1. **Project Address:** 800 North Block, East Washington Avenue
Project Title (if any): the Galaxie

Owner: Otto Gebhardt, Gebhardt Development
Project Name: the Galaxie Phase I & II
Purpose: UDC Design Progression Submission

Location: 800 North Block of East Washington Avenue,
Madison WI
Architect: Midwest Modern, LLC

UDC DESIGN PROGRESSION

RF ROOF FARM PLAN AT 5TH FLOOR PARKING ROOF/ 4TH RESIDENTIAL

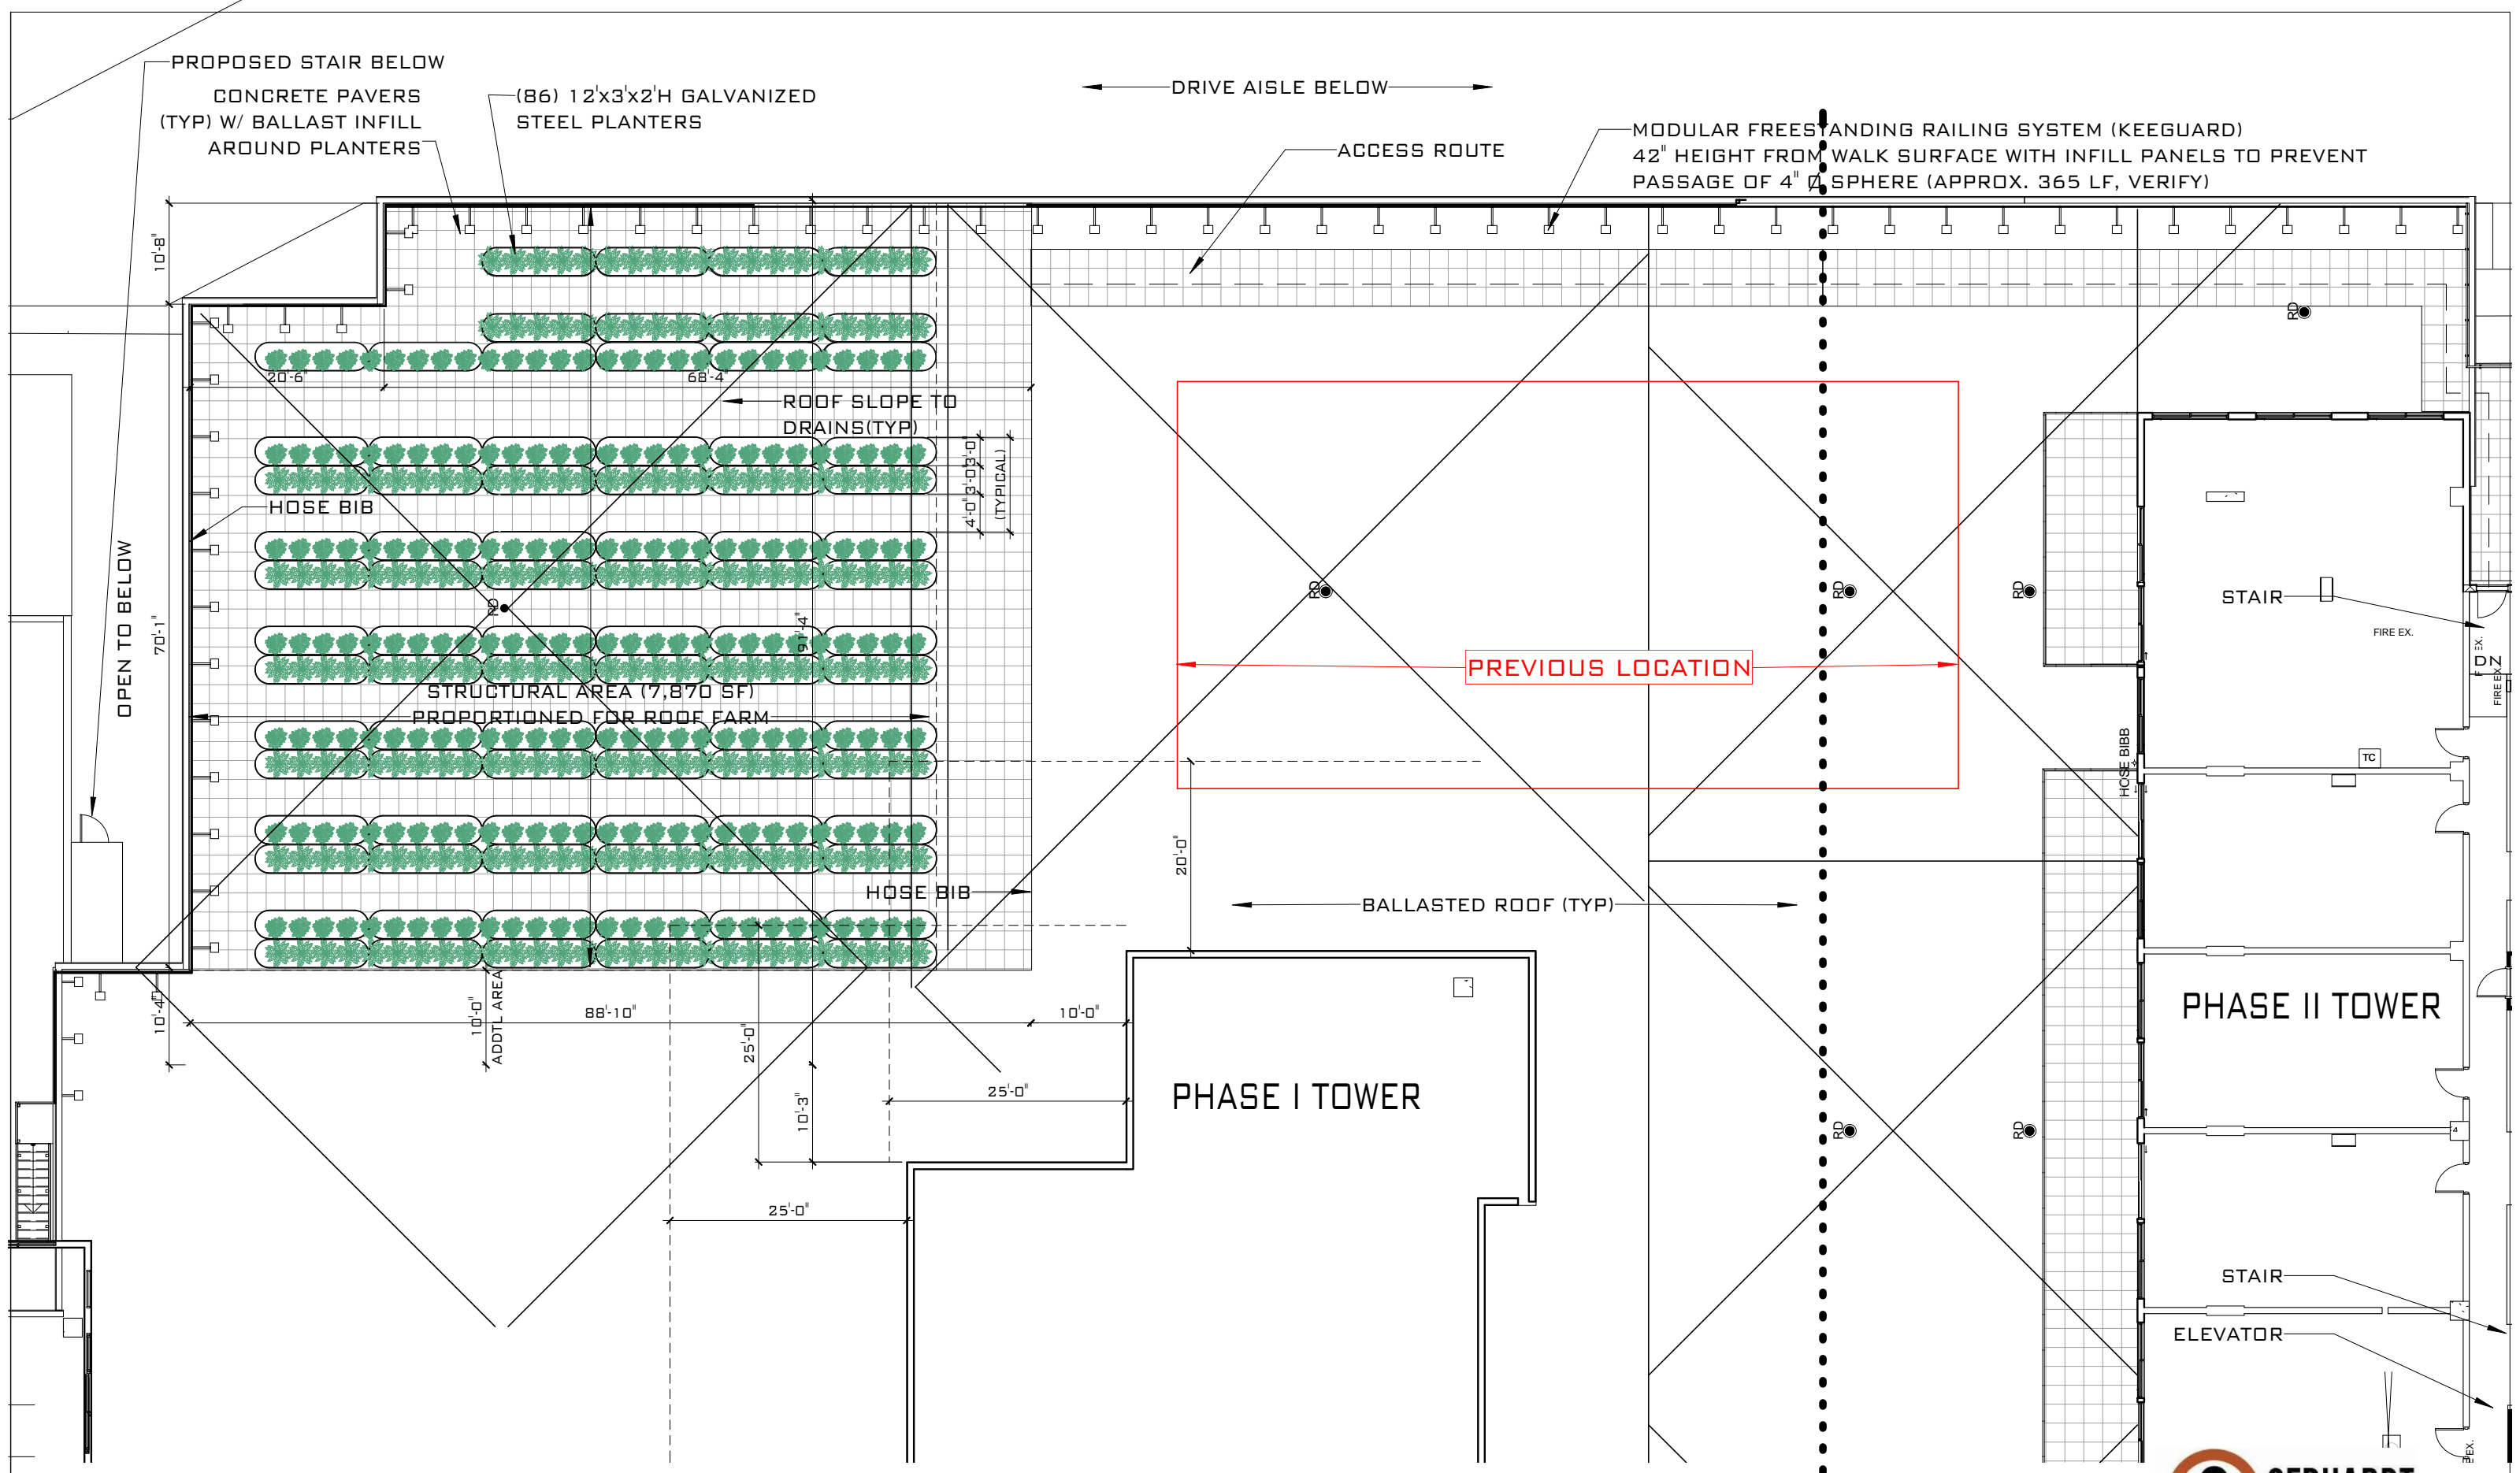
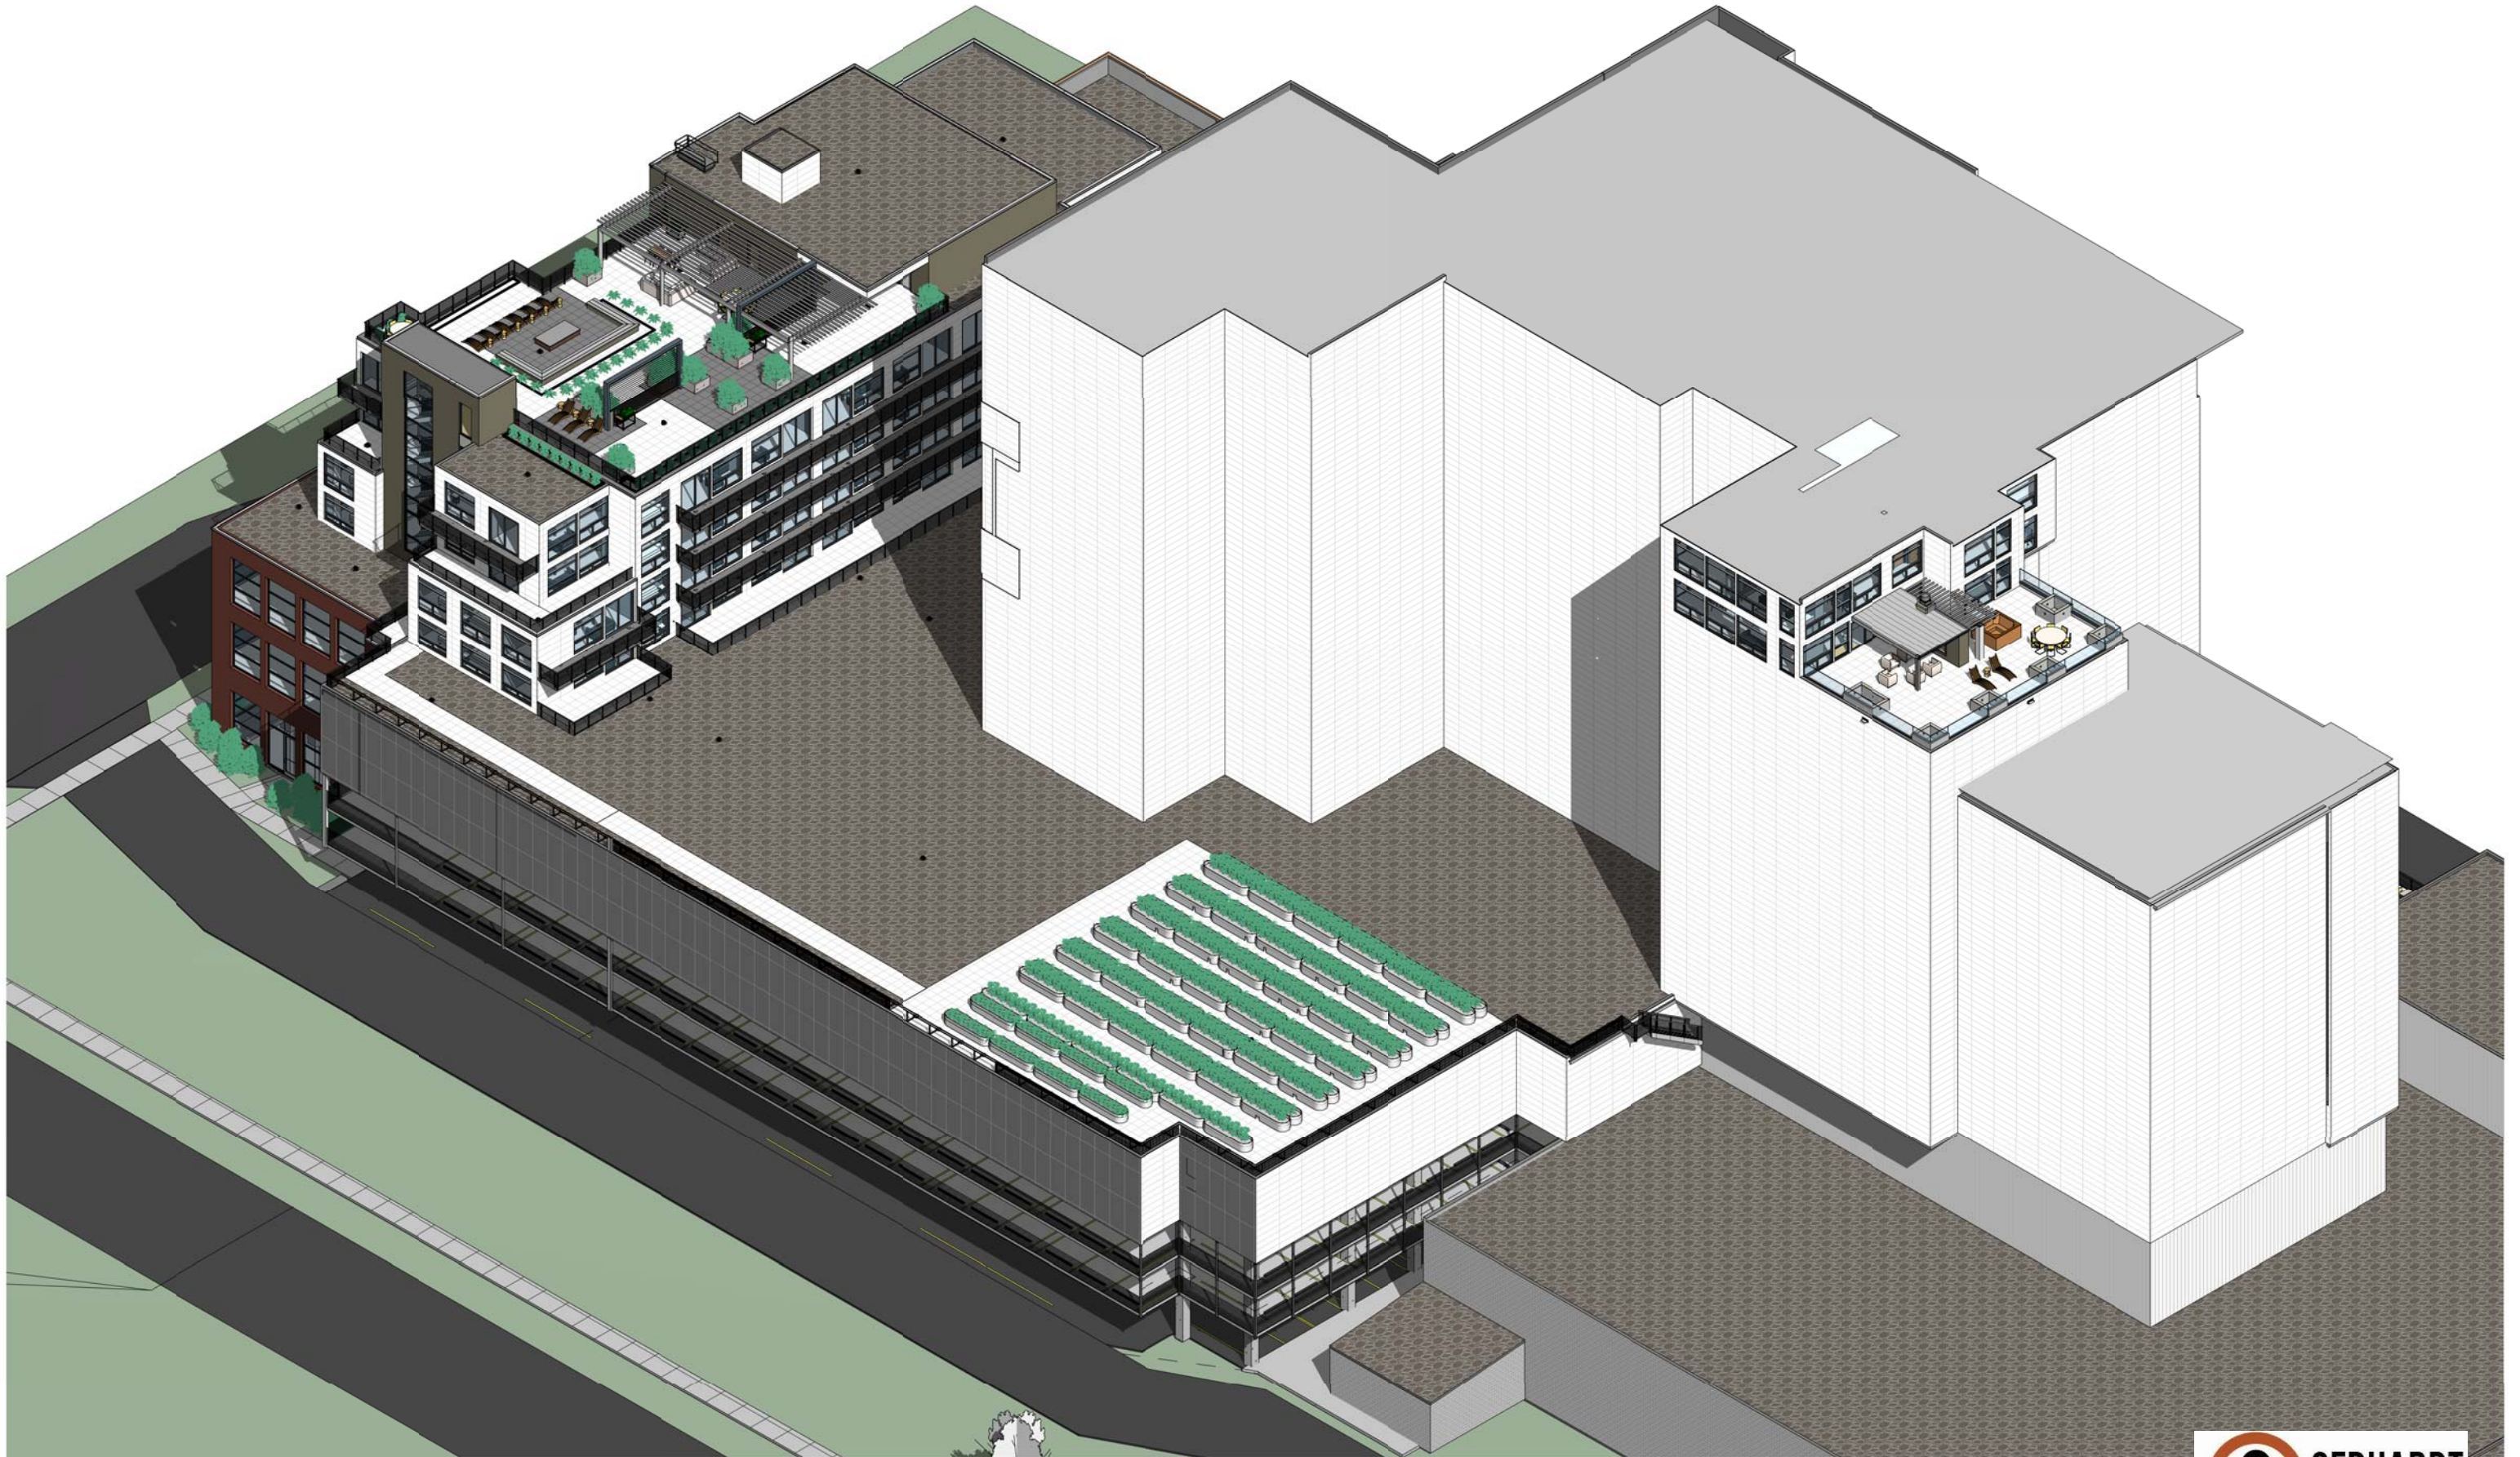
4. Relocate roof farm above 5th floor parking roof adjacent to Phase I tower.

Reason: Further coordination with structural engineer determined that the area engineered for added weight is further to the south.

The relocated roof farm will utilize galvanized steel tanks as planters situated within concrete pavers with roof ballast stone infill at corner conditions. The relocated roof farm location will have access through the Phase II tower with an additional proposed stair location (to be installed if required for exiting) that will connect to the 5th floor of the parking garage at the rear of the 3rd floor mechanical mezzanine. A modular, free-standing guardrail system will be utilized to provide fall protection around the perimeter of the roof farm area above the drive aisle with ballast roof surrounding the area. There is no change to the management planned for the roof farm. The operator that is planned to utilize the roof farm plans to grow greens, edible flowers, and asparagus.
